European Code for Inland Waterways (resolution No. 24, revision 5)

Consolidated text of amendments to the European Code for Inland Waterways (resolution No. 24, revision 5)

**Consolidated text of the approved amendments to the
European Code for Inland Waterways, revision 5, and
additional amendment proposals transmitted by the CEVNI
Expert Group**

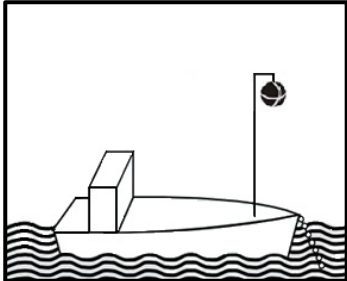
79 Add new sketches 35 bis and 35 ter:

Article 3.21: Additional marking for stationary vessels carrying out certain transport operations involving dangerous substances in accordance with article 3.14, paragraph 2.

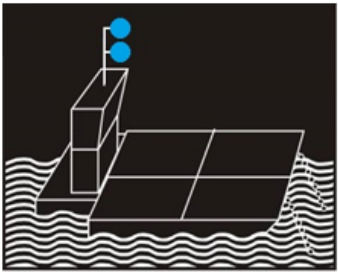
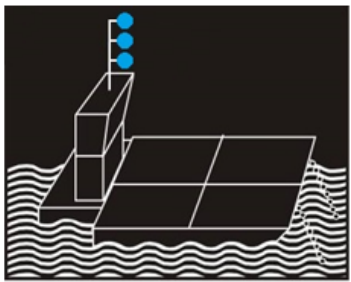
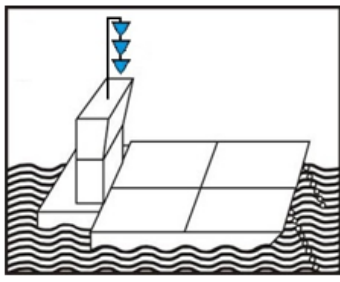
83	Add new sketches 49 bis – 49 quinquies	ECE/TRANS/SC.3/ WP.3/2021/1
----	--	--------------------------------
